From: Chris Hiener <chiener@unionfiredistrict.com>
Sent: Monday, September 20, 2021 10:31 AM
To: dkm@groundbreaking-designs.com
Subject: RE: Fire Flow Requirement: North Woods Subdivision - Curtis Corner/South Rd.
Attachments: UFD TurnAround Details-2021.pdf

From: dkm@groundbreaking-designs.com <dkm@groundbreaking-designs.com>
Sent: Monday, September 13, 2021 1:36 PM
To: Chris Hiener <chiener@unionfiredistrict.com>
Subject: Fire Flow Requirement: North Woods Subdivision - Curtis Corner/South Rd.

I am working with Michael O'Brien and Earl Greco of Osprey Builders and True North Land Company on the proposed subdivision project "North Woods Subdivision" at the intersection of Curtis Corner and South Road. I know that Earl and Michael have already discussed with you about the proposed roadway layout and the location of the one hydrant. I will get to you the dimensions of the road and turning radiuses, but for now I am working with the water department on the design of the water line for the subdivision and need to know what the required fire flow is for that one hydrant. Can you please send an email or write a letter dictating the required fire flow?

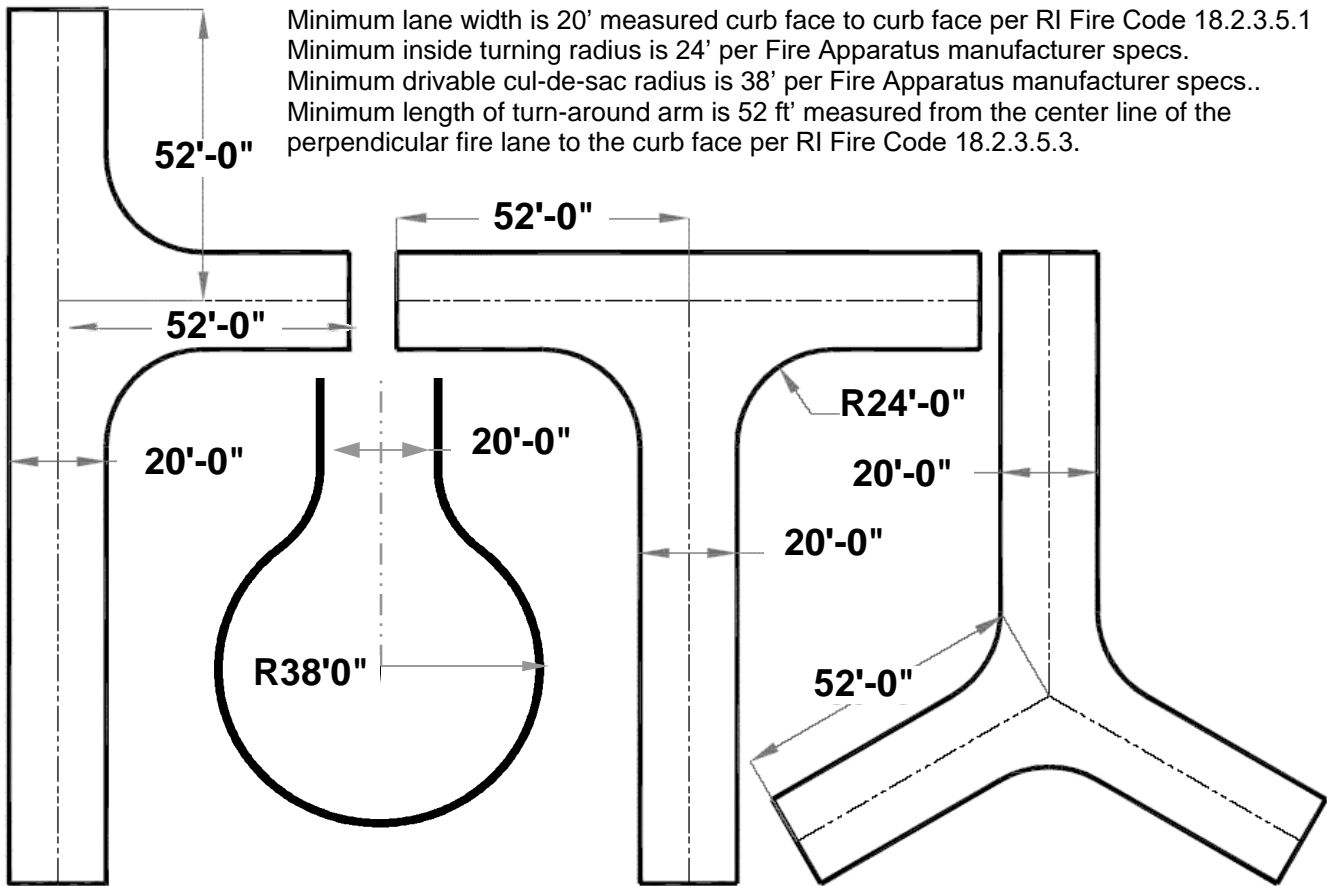
I have reviewed you plans.

Per RI Fire Code a Fire Department access road must extend to within 50' of at least one exterior door.

See RIFC (NFPA 1) 18.2.3 Fire Department Access Roads

I have attached turning radius paperwork. Please indicate dimensions of turn around to ensure we will be able to turn around our Ladder Truck.

Add Fire Hydrant at corner of Curtis Corner Rd.
